July 31, 2023

ADDENDUM NO. ONE (1)

PROJECT: PV-TEC Building Remodel

DATE: JUL 23
 DRAWING NO. A5.1
 JOB NO. 2306
 18 OF 49

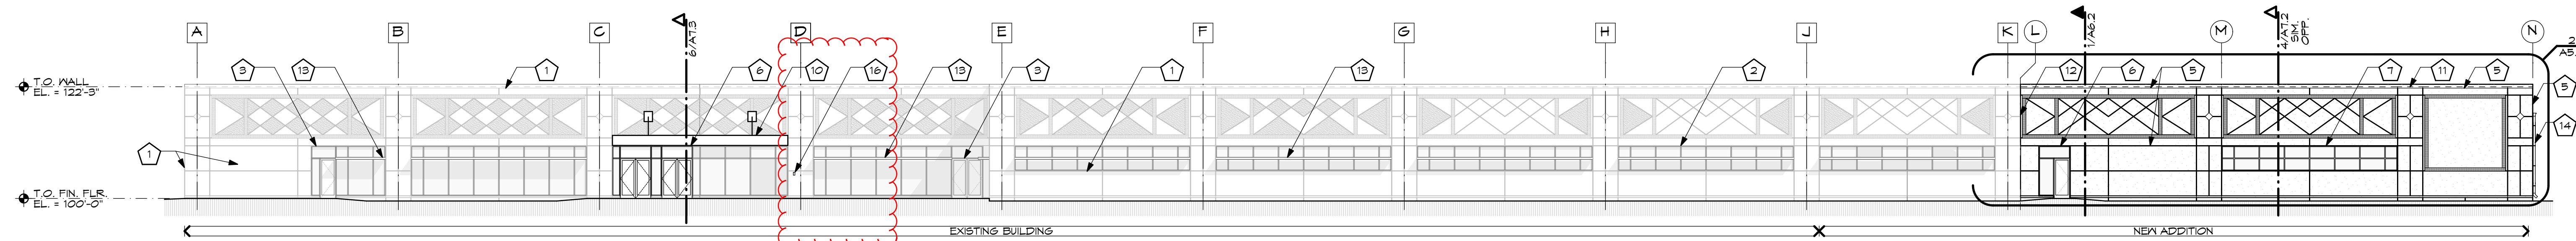
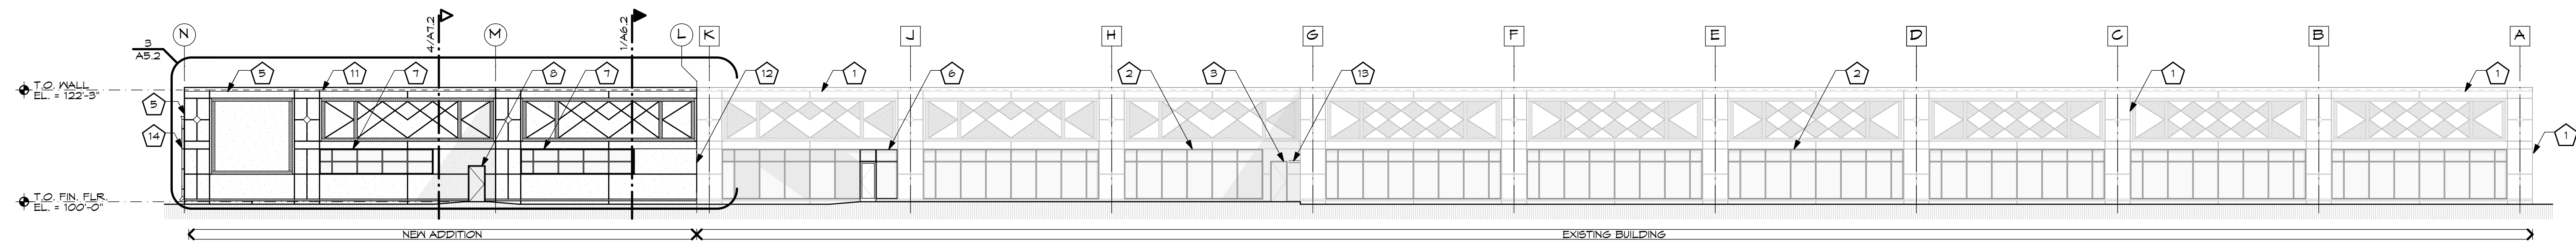
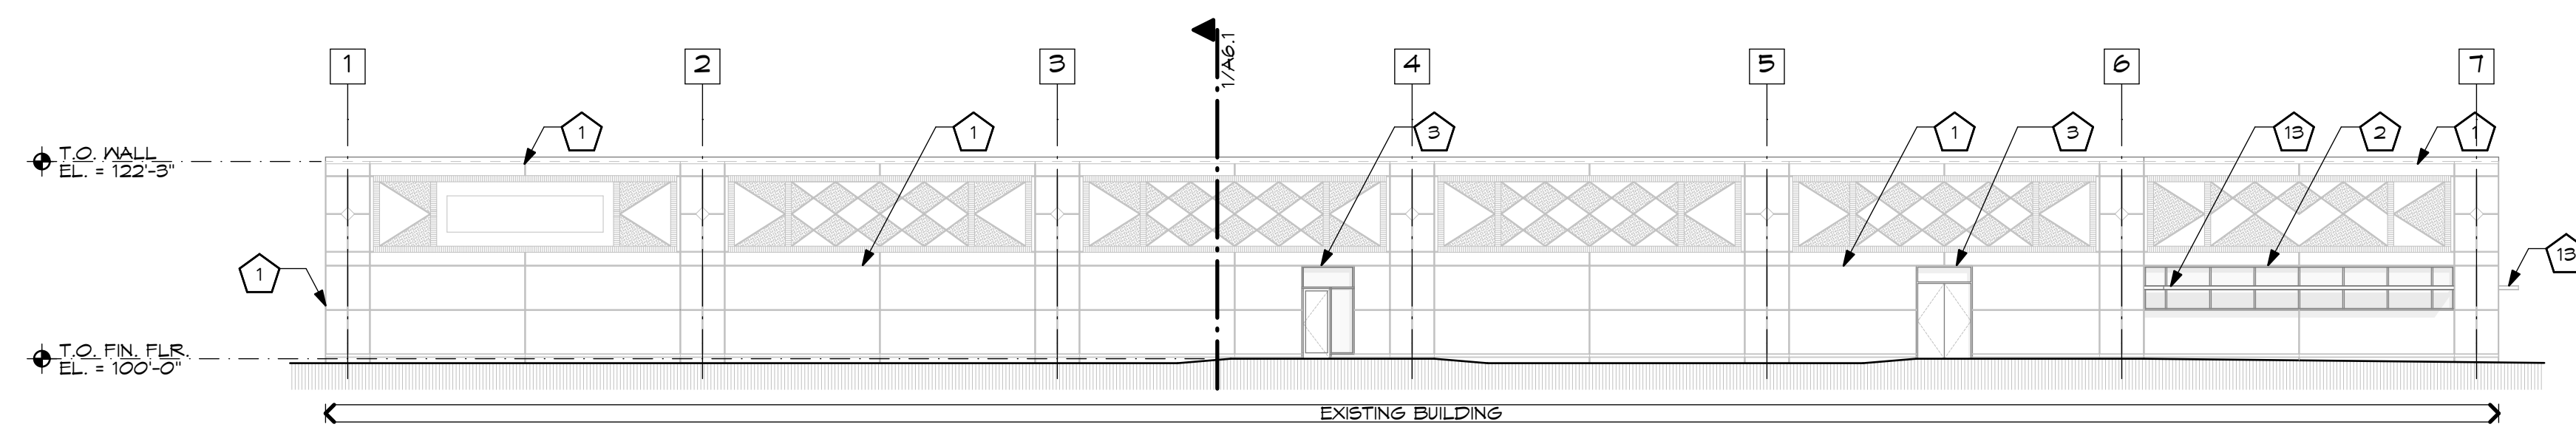
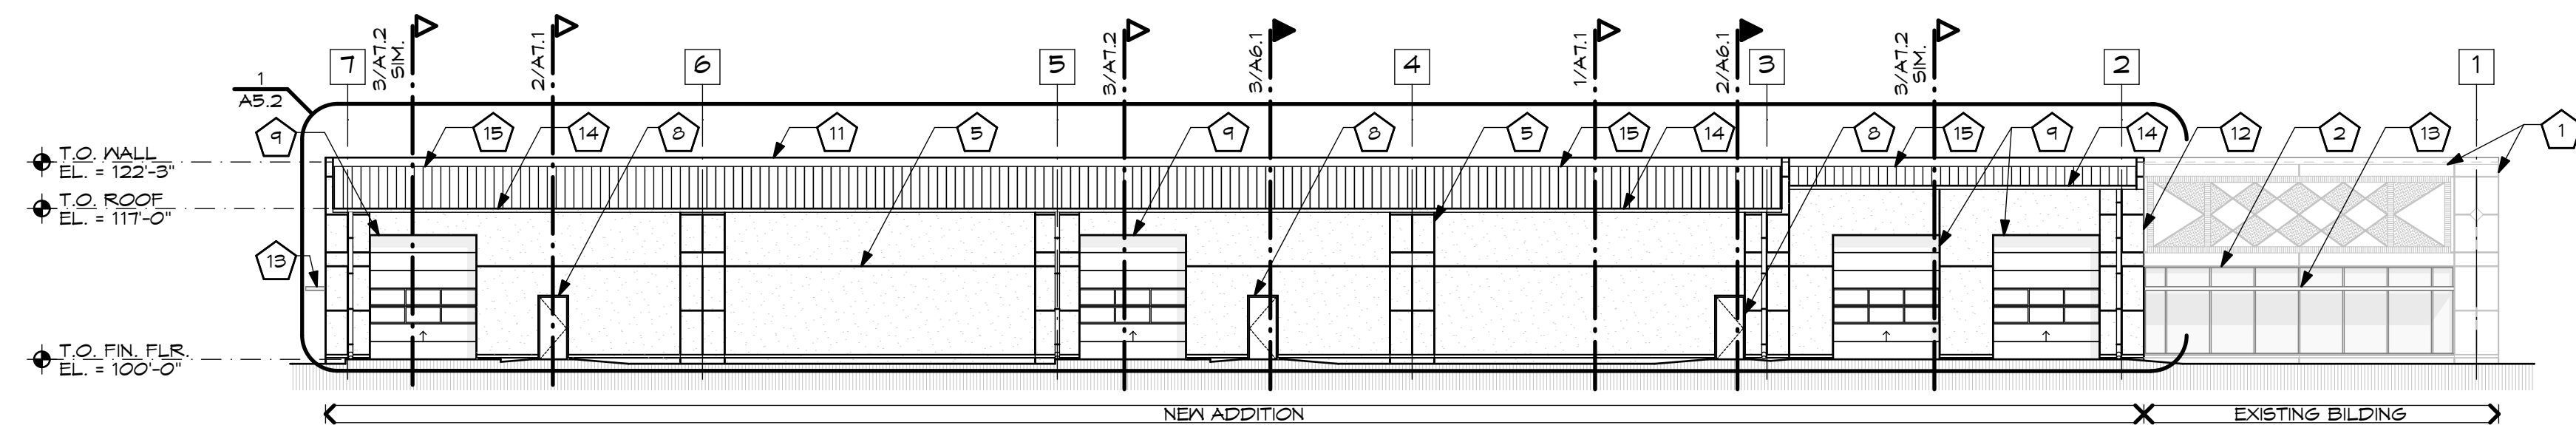
- D1 A5.1 – Keyed note 16 has been added to sheet A5.1. Note indicates location of new knox box.
- D2 E5.0-E5.3 – Sheets E5.0-E5.3 contain information regarding classroom sound systems. Please include in base bid.
- D3 E Sheets – Cat 6A Belden Solution is acceptable for horizontal IT cabling.
- D4 EC shall provide fire alarm system modifications as shown on the fire alarm drawings. Contact State Fire of Idaho. Contact information is shown on the Fire Alarm Drawings. EC shall submit fire alarm drawings and all required calculations to local AHJ, obtain a written letter of acceptance, and submit with fire alarm system shop drawings.

- 15 PREFIN. MTL. STANDING SEAM ROOF - PROVIDED BY OWNER AND INSTALLED BY CONTRACTOR
- 16 NEW KNOX BOX LOCATION
